Access Compliance Report

Public Rights-of-Way

Intersection ID: 27418	Main Street: BALLANTYNE COMMONS PY	Cross Street: BALLANTYNE TRACE CT	Location: NE
ADA ID: 33E97DFA6F9E	Ramp Type: Perp	Initial Pass/Fail: Fail	Overall Compliance: No
Severity Score: 33.75			
Codes/Mitigation Info/Possible Solution		Field Measurements/Component Compliance

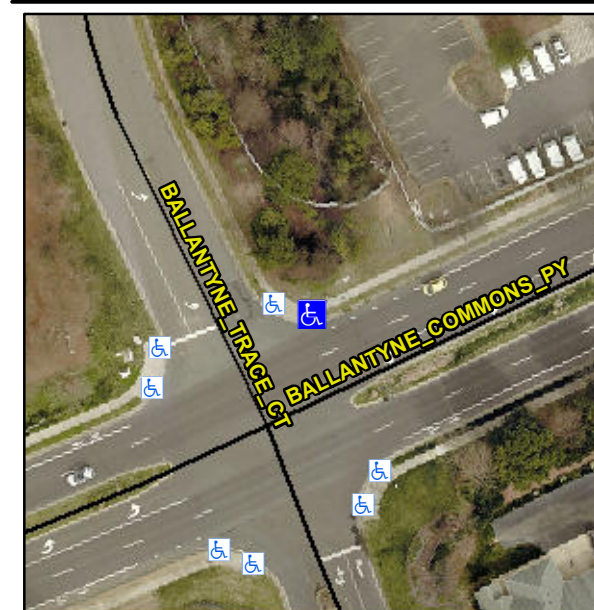
Not Found, R304.5.1, R304.5.3

Compliance	Description	Data	Compliance	Description	Data
N/A	Ramp Length (in)	96.0	Yes	Ramp Slope (%)	5.2
No	Ramp Width (in)	47.5	No	Ramp XSlope (%)	10.4
N/A	Flare Type LT	N/A	N/A	Flare Type RT	N/A
N/A	Flare Slope LT (%)	N/A	N/A	Flare Slope RT (%)	N/A
N/A	Flare Traversable LT?	N/A	N/A	Flare Traversable RT?	N/A
N/A	Landing Length (in)	N/A	N/A	DWS Provided?	N/A
N/A	Landing Width (in)	N/A	N/A	DWS Contrast?	N/A
N/A	Landing Slope (%)	N/A	N/A	DWS Length (in)	N/A
N/A	Landing X Slope (%)	N/A	N/A	DWS Full Width?	N/A
N/A	Landing Curb? (Y/N)	N/A	N/A	DWS Offset (in)	N/A
N/A	Shared Landing?	N/A			
N/A	Gutter Ponding?	N/A	N/A	Gutter Slope (%)	N/A
N/A	Gutter Lip Ht (in)	N/A	N/A	Gutter X Slope (%)	N/A
N/A	Painted X Walk1?	No	N/A	Painted X Walk2?	N/A
	X Walk 1 Direction	To S		X Walk 2 Direction	N/A
N/A	X Walk 1 Width (in)	N/A	N/A	X Walk 2 Width (in)	N/A
	X Walk 1 Slope (%)	2.5		X Walk 2 Slope (%)	N/A
	X Walk 1 X Slope (%)	5.7		X Walk 2 X Slope (%)	N/A

Remove & Replace Entire Ramp.
